Meeting:	Overview and Scrutiny	Date:	4 November 2019
	Cabinet		6 November 2019
	Council		21 November 2019
Subject:	Supplementary Planning Documents for Podsmead Estate Regeneration and Matson Estate Regeneration		
Report Of:	Cabinet Member for Planning and Housing Strategy		
Wards Affected:	Podsmead and Matson		
Key Decision:	Yes	Budget/Policy Framework:	Yes
Contact Officer:	Claire Haslam Principal Planning Officer		
	Email: Claire.haslam@gloucester.gov.uk	Tel:	39-6825
Appendices:	1. Summary of Responses by Topic 2. Response Report Matson 3. Response Report Podsmead 4. Draft Supplementary Planning Document - Podsmead Estate Regeneration 5. Draft Supplementary Planning Document - Matson Estate Regeneration

- 1.1 To provide Members with a summary of comments received during the public consultation of the Matson and Podsmead Estate Regeneration Draft Supplementary Planning Documents (SPDs), the changes made to the draft SPDs in response to these comments, and to seek the adoption by Council of the draft SPDs.

Fig 2.17: Pedestrian links are hard to find

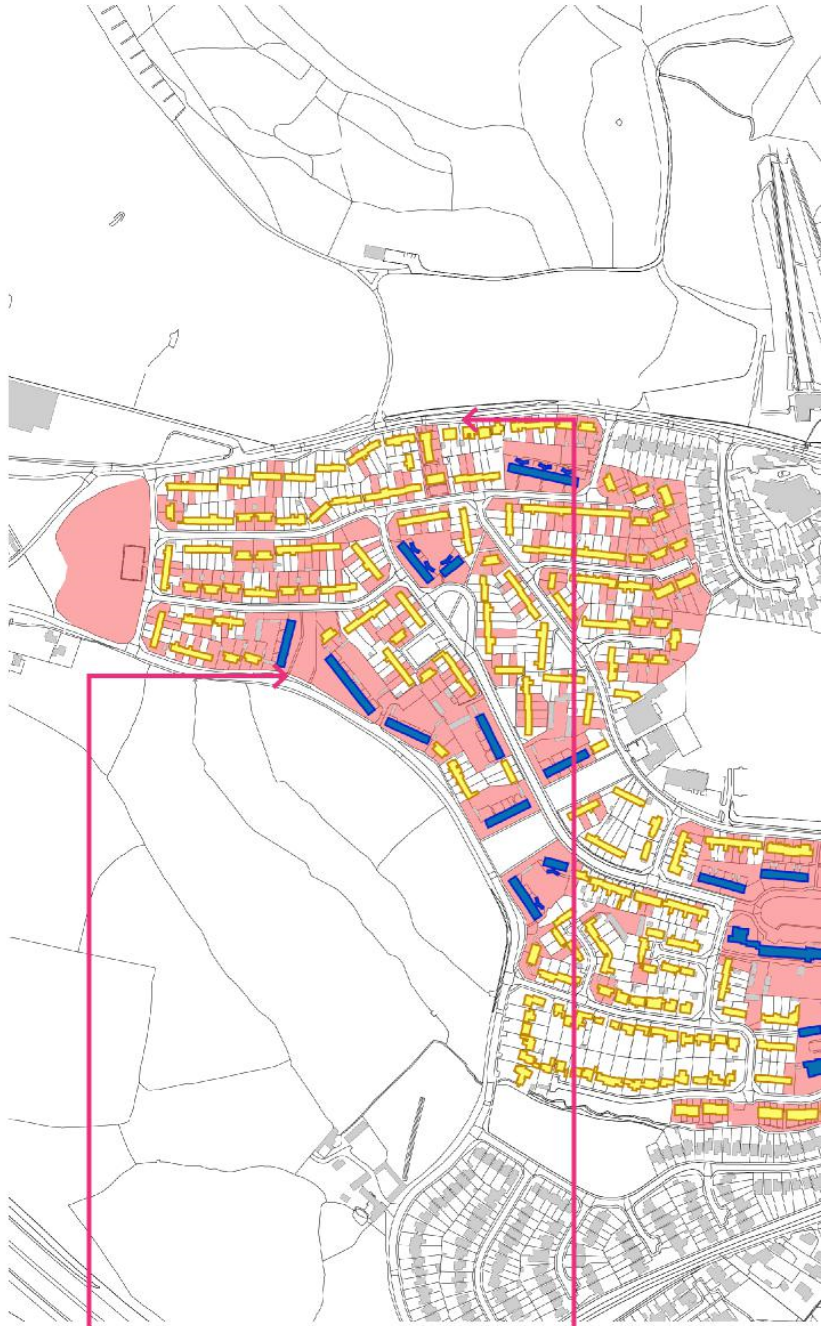
<<REMOVE ARROW ACROSS MOAT SCHOOL>>

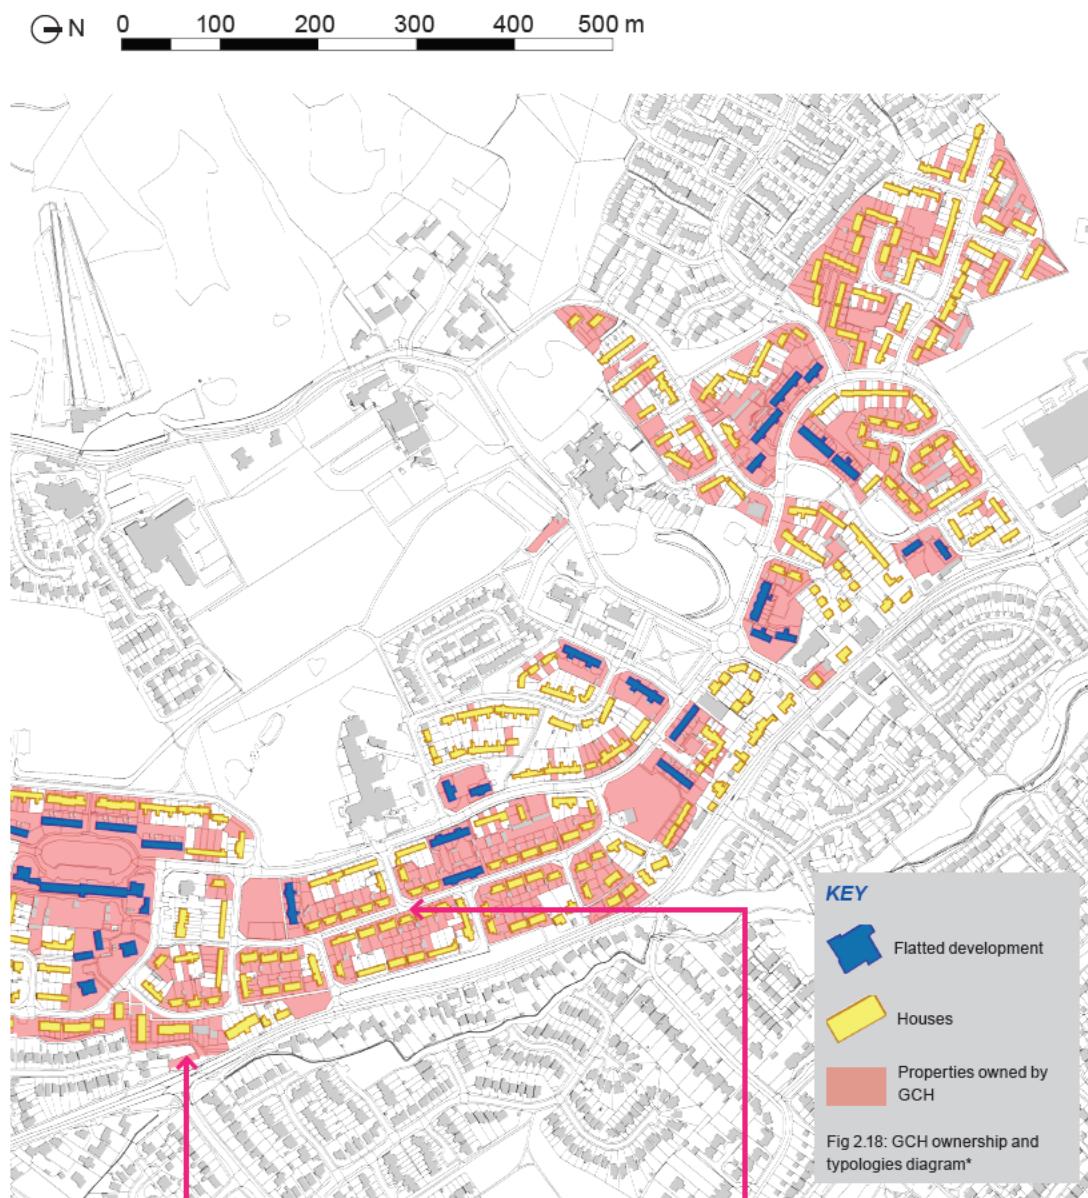
2.3.2 - "...open space that lacks a clear use..." - bias against the passive use of open space	Open Space	Noted.	Add reference to passive open space to 2.2.2
Figure 2.22: Existing semi-detached housing image is in face maisonettes in Winsley Road and not semi-detached houses.	Homes	Noted.	Substitute photograph in Figure 2.2 to show semi detached property.

<<LABEL CHANGE TO Figure2.22: Existing maisonnettes>>

Fig 2.23: Diagram of Public Open Spaces within Study Area

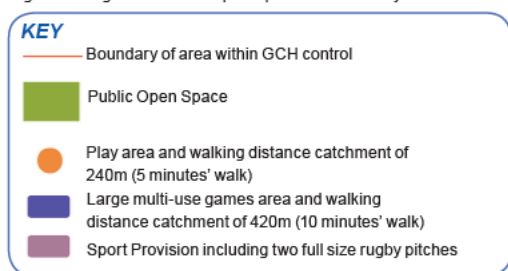
<<Figure 2.23 is missing a play area and a pitch. GCH will update. 'large' will also be removed from the key>>

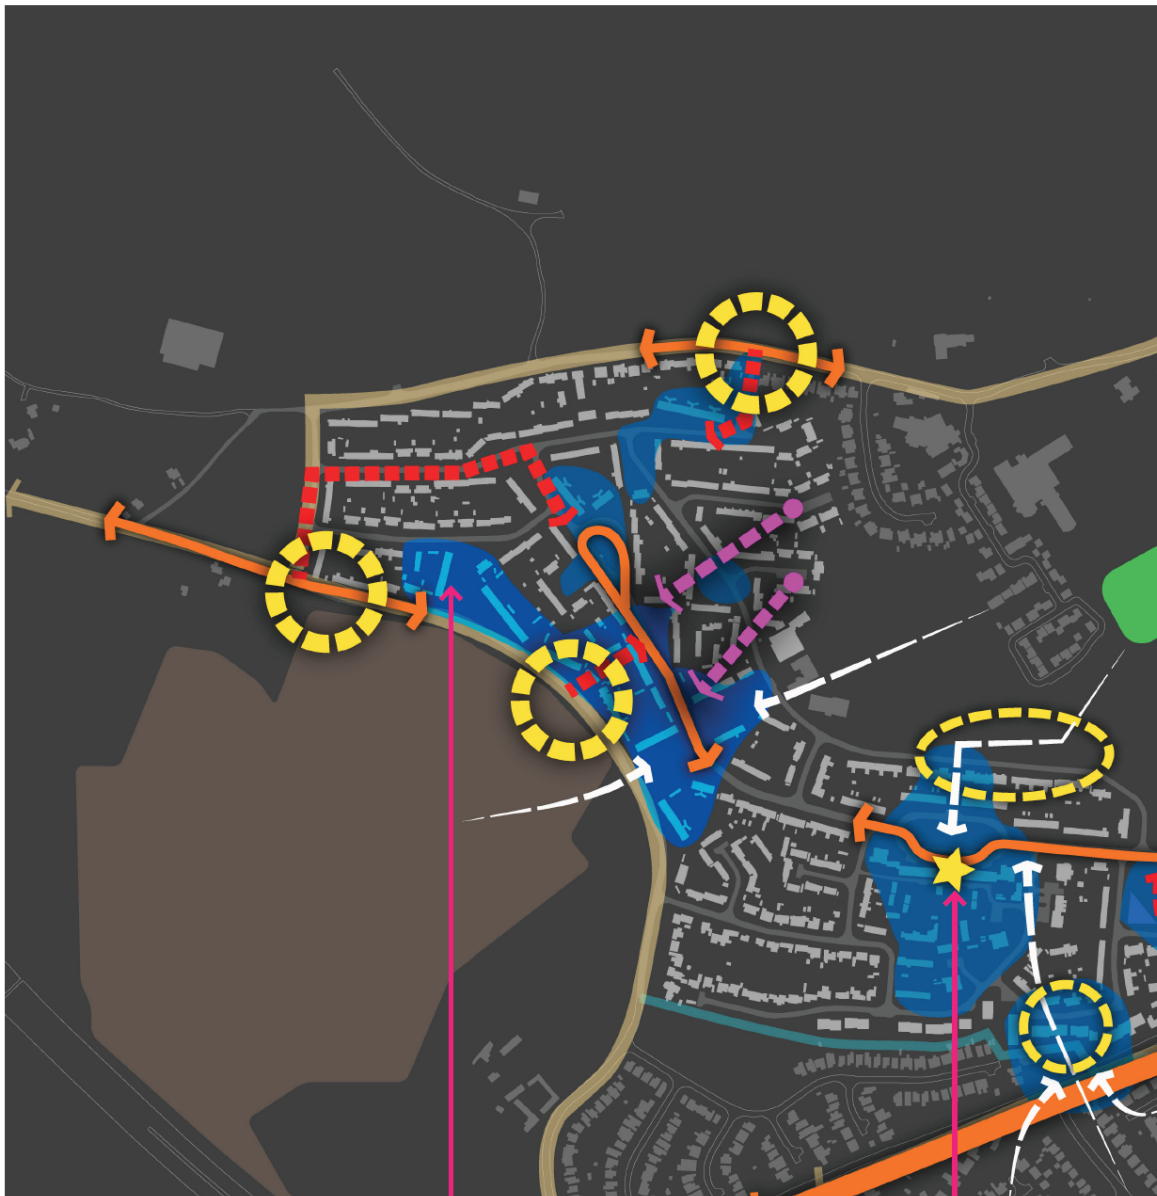
<<GCH TO ADD STREET NAMES TO FIGURE 2.24 Opportunities diagram>>
 <<Add arrows for opportunity to connect to Robinswood Hill and Matson Lane>>
 <<Orange arrow not on Key>>
